SUBJECT: Forwards addl info re svc water sys effluent monitoring, in response to SER Open Item 11 from Meteorology & Effluent Treatment Branch.

SHEARON HARRIS NUCLEAR POWER PLANT
UNIT NO. 1 - DOCKET NO. 50-400
MONITORING OF THE SERVICE WATER SYSTEM

Shearon Harris Nuclear Power Plant
SER Open Item 11
Monitoring of the Service Water System

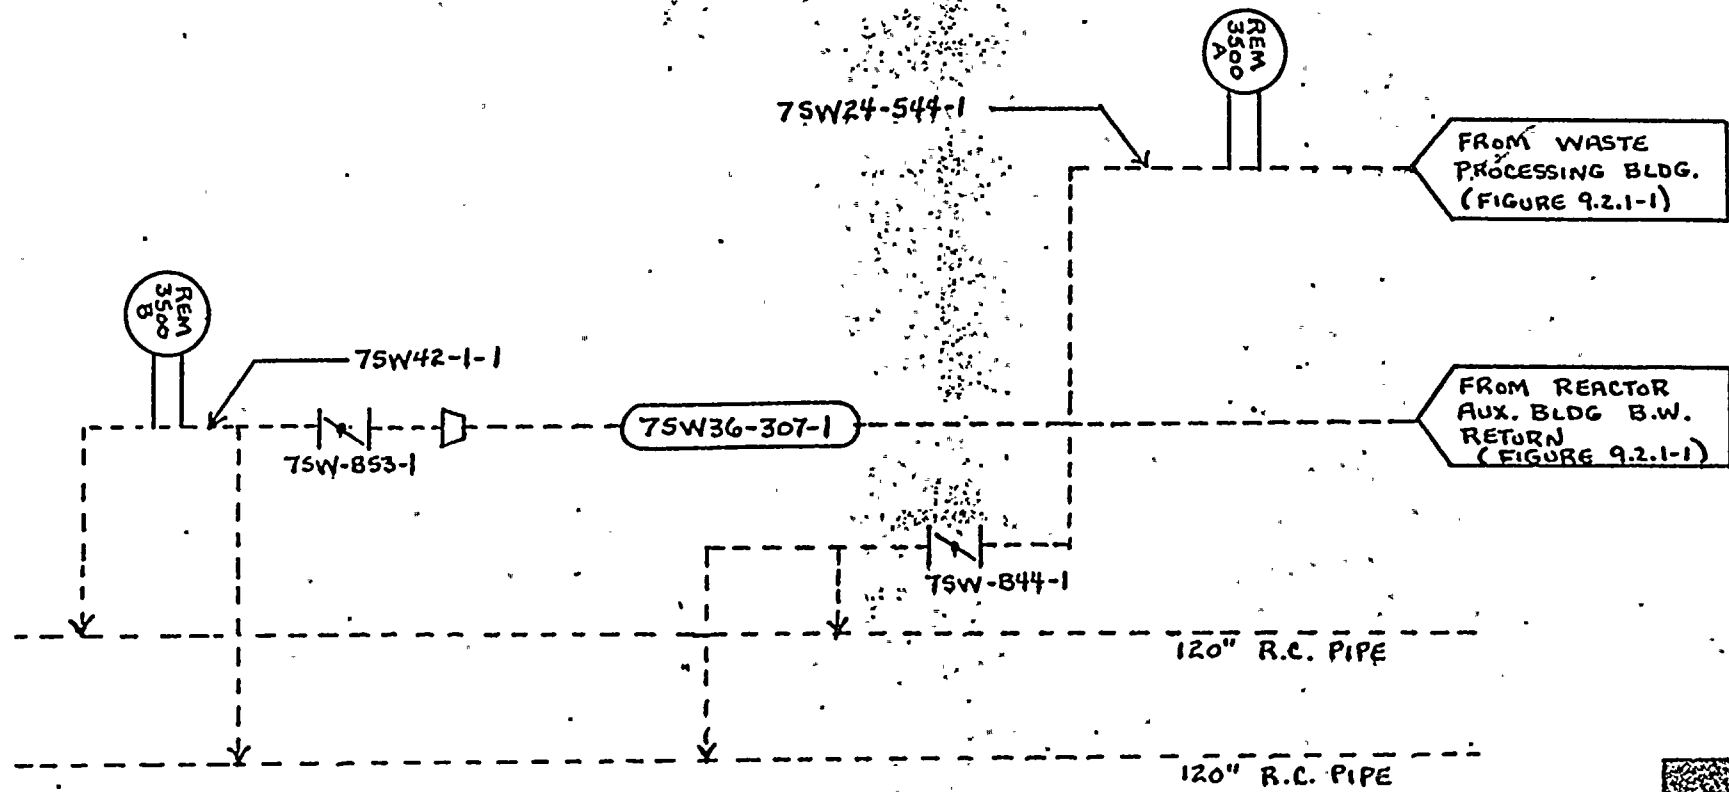
The service water system, waste processing building cooling water system, and RAB backwash return line are not monitored downstream of all potential radioactive inputs to the system. The liquid monitor for the emergency fan coolers is not adequate for the service water system.

Off-line liquid radiation monitors REM-3500A and REM-3500B, which monitor the discharges of fan coolers AH-1 and AH-2, will be relocated to the service water lines discharging into the circulating water system. Liquid radiation monitor REM-3500A will be relocated to line 7SW24-544-1 in the WPB prior to valve 7SW-B44-1 shown on FSAR Figure 9.2.1-2. Liquid radiation monitor REM-3500B will be relocated to line 7SW42-1-1 in the turbine building after valve 7SW-B53-1 shown on FSAR Figure 9.2.1-2. Liquid radiation monitors REM-3500C and REM-3500D will be deleted. Liquid radiation monitors REM-3500A and REM-3500B are described in FSAR Sections 11.5.2.5.7 and 11.5.2.6.2, which include information on detector capability, sensitivity, and range. As stated in FSAR Section 11.5.1.3, liquid radiation monitors are provided with grab sample capability. The service water system, downstream of all inputs, will be monitored continuously prior to discharge to the circulating water system.

Attached is a sketch showing the affected lines from FSAR Figure 9.2.1-2 and the new locations of liquid radiation monitors REM-3500A and REM-3500B. Draft pages for FSAR Section 11.5.2.7.1 and FSAR Table 11.5.2-2 have also been attached for your information. FSAR Figure 9.2.1-2, FSAR Section 11.5.2.7.2.1, and FSAR Table 11.5.2-2 will be formally revised in a future FSAR amendment to incorporate this response.
